# WARRANTY BULLETIN

Campaign no.: 2014-0003

Subject: **A - Fast Flasher Blink Rate**  
**B - Possible Defective Ignition Key**  
**C - Front Storage Compartment Cover and/or Seat Will Not Open - Defective Ignition Switch**

**REVISION 2**  
**May 29<sup>th</sup>, 2014**

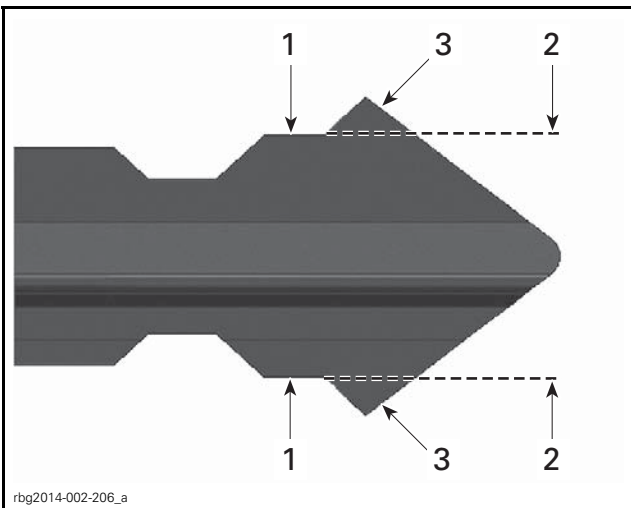
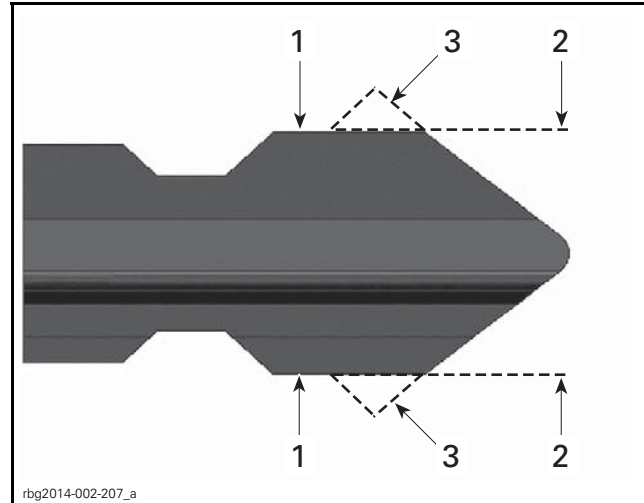
2. Using a small rotary tool, grind off the last point on both sides of the end of the key.

NOTE: The height of the last flat surface will vary with the key code. The modified surface **must be in line with and square** to the last flat surface of the key.

1. Reference flat surface  
2. Cut line  
3. Material to remove

1. Reference flat surface  
2. Cut line  
3. Material removed

## ► D.E.S.S. Antenna Replacement ◀

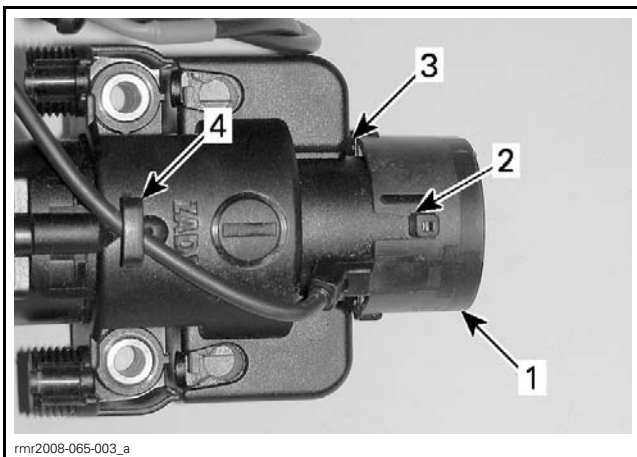
► Follow procedures as detailed in references except for the following:

= On all models, remove the console module (see PROCEDURE REFERENCES).

= Do not remove the front cargo module.

= Do not disconnect the D.E.S.S. antenna at the D.E.S.S. module. Instead, remove the D.E.S.S. antenna from the ignition switch already in the vehicle and install it on the new ignition switch assembly. Refer to D.E.S.S. ANTENNA REPLACEMENT further in this bulletin.

1. ► Carefully pry off the D.E.S.S. antenna from the OLD switch before removing the switch from the vehicle.

2. Carefully pry off the D.E.S.S. antenna from the NEW switch.

3. Position NEW ignition switch near handlebar and install the OLD D.E.S.S. antenna on the new switch.
